## Accessibility Survey

## City of Downey Horley Avenue - Adwen Street To Arnett Street

Date of Inspection  
4/11/2017

Prepared By  
**Disability Access Consultants**  
(800) 743-7067

**Change In Level North Of Adwen Street @ 33.942758045793, -118.145144730806**

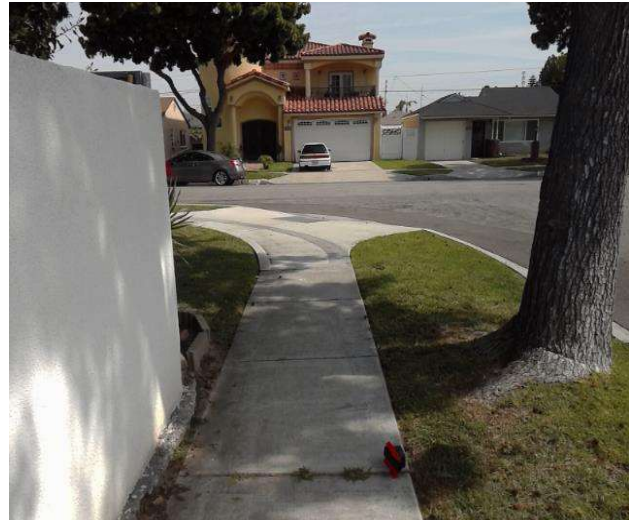
There is a change in elevation greater than recommended value.

**On-Site Finding** 0.50 inches

Ensure that the change in elevation is within the recommended value.

Recommendation Up to 0.25 inches
